February 7, 1994

Re: Response of DEHNR Comments
Halifax County Ash Monofill
Construction Record Documentation Report
H&S No. 3716

Reference: Response to Comments Regarding
Halifax Density Test Data
Halifax County Landfill
Halifax County, North Carolina
GeoTechnologies Project No. 1-92-367-CB

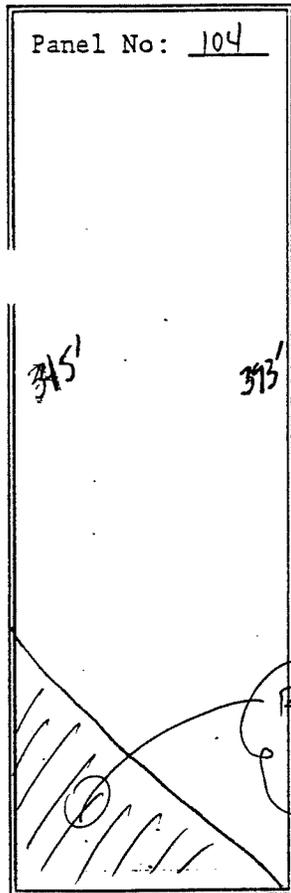
1. Darker copies of reports for panels 87, 88, 92, 94, 97, 98, 100-106, 111, 126-128, 130, and 134 are attached.
2. For Panels 104-111, cross hatched areas indicate where adjacent panels subsequently overlapped the panel in question.
3. Panels 112 and 115 represent areas indicated as questionable by the technician when the panel was first deployed. Later review by the Resident Engineer indicated that no repair was necessary. The questionable areas were crossed out and noted with "OK SAS" by the Resident Engineer on the Panel forms.
4. Geomembrane seaming equipment was monitored for set and actual temperatures during prewelds and prior to seaming each seam. Major fluctuations in actual temperature were recorded during seaming if observed.

SEAM NO. 7-8
 SEAM LENGTH 40'
 COMMENTS OK

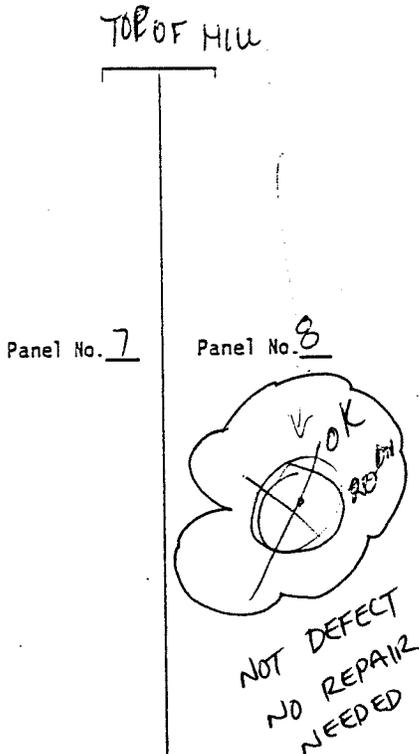
1. Seams 7-8, 9-8, 15-14, 18-19, 48-49, 51-52, 64-63, 142-143, 151-152 represents questionable areas marked by the technician when the seam was being welded. Later review by the Resident Engineer indicated that a repair was not needed. This has been clarified on revised Seam Inspection Forms, which are attached.

SEAM NO. 89-88
 SEAM LENGTH 392
 COMMENTS DS #8
 WELDING UNIT NO. 327
 TIME WELDED 12:05 a.m./p.m.

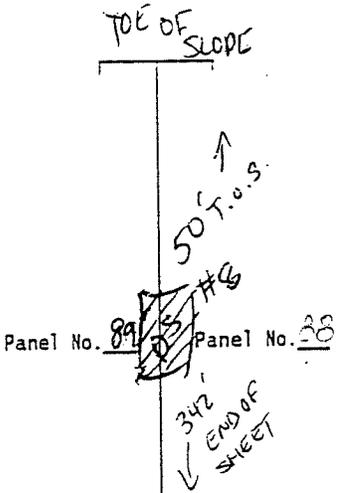
2. Seams 87-89, 89-88, 178-179 were vacuum tested according to project specifications but this information was not transferred to seam inspection sheets. During final walkthrough each patch was checked for "V.T. OK" written on patch to confirm testing was completed. Revised Seam Inspection Forms are attached.

SEAM NO. 71-70
 SEAM LENGTH 39'
 COMMENTS OK
 WELDING UNIT NO. 851
 TIME WELDED 9:15 a.m./p.m.

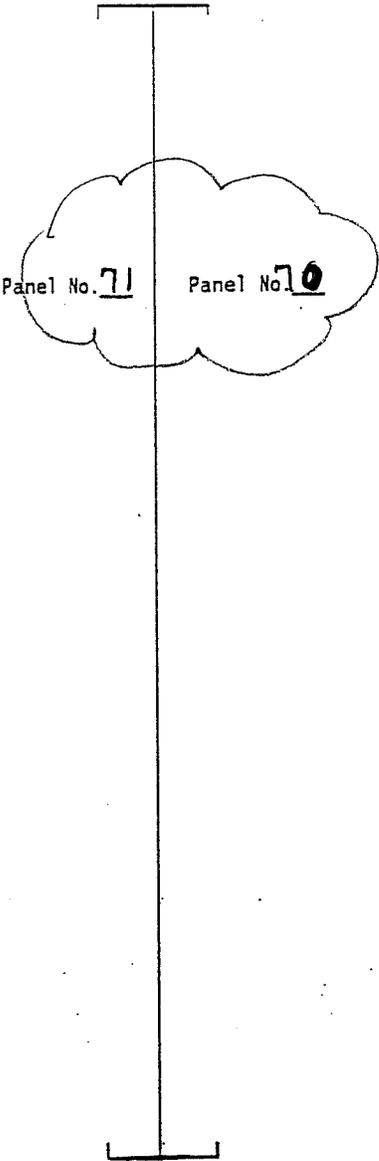
8. Seam Inspection Form 71-70 was not labeled for orientation. This form has been corrected to show orientation and is attached.
